Access Compliance Report Public Rights-of-Way (Curb Ramps)

Main Street: CERRERO_CT Cross Street: SALIENTE_RD Location: NW

ADA ID: RPRK211129141324 Ramp Type: Type 1 - Perpendicular Initial Pass/Fail: Fail Overall Compliance: No Severity Score: 32

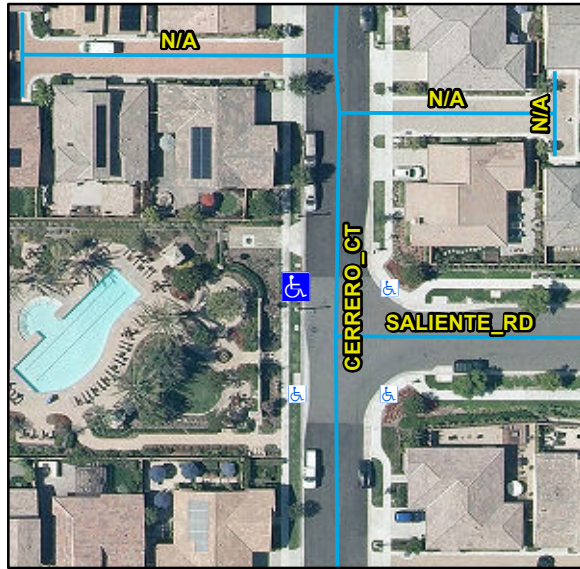
Compliance	Description	Data	Compliance	Description	Data
N/A	Ramp Length (in)	72	N/A	Flare Type LT	
Yes	Ramp Width (in)	60			N/A
No	Ramp Run Slope (%)	17.3	N/A	Flare Slope LT (%)	N/A
Yes	Ramp Cross Slope (%)	1.6	N/A	Flare Traversable LT	N/A
N/A	Landing Present	N/A	N/A	Flare Type RT	
N/A	Landing Length (in)	N/A			N/A
N/A	Landing Width (in)	N/A	N/A	Flare Slope RT (%)	N/A
N/A	Landing Run Slope (%)	N/A	N/A	Flare Traversable RT	N/A
N/A	Landing Cross Slope (%)	N/A	N/A	DWS Provided	N/A
N/A	Landing Movement Obstructed?	N/A	N/A	DWS Contrast	N/A
	Landing Movement Type	N/A	N/A	DWS Length (in)	N/A
N/A	Landing Shared	N/A	N/A	DWS Full Width	N/A
N/A	Clear Space	N/A	N/A	DWS Offset Left (in)	N/A
N/A	Clear Space To Crosswalk (in)	N/A	N/A	DWS Offset Right (in)	N/A
N/A	Marked Crosswalk 1	No	N/A	Marked Crosswalk 2	N/A
	Crossing 1 Direction	E		Crossing 2 Direction	N/A
	Marked Crosswalk 1 Width (in)	N/A		Marked Crosswalk 2 Width (in)	N/A

N/A	Ramp Inside Crosswalk 1	N/A	Yes	Ramp Inside Crosswalk 2	N/A
	Crossing 1 Slope (%)	5.3		Crossing 2 Slope (%)	N/A
	Crossing 1 Cross Slope (%)	0		Crossing 2 Cross Slope (%)	N/A
N/A	Gutter Ponding	N/A	No	Curb Slope	8.2
No	Gutter Lip Height (in)	0.25		Road Run Slope (%)	N/A
N/A	Gutter Run Slope (%)	N/A		Road Cross Slope (%)	N/A
N/A	Gutter Cross Slope (%)	N/A			
Yes	Overall Surface Condition: Acceptable		Yes	Perp Joint Present	Yes
	Cross Gutter Present?	No		Spandrel Present?	No
	Replace Cross Gutter?	N/A		Replace Spandrel?	N/A

Remove & Replace Entire Ramp.

R304.2.2, R302.7.2, STD 1115
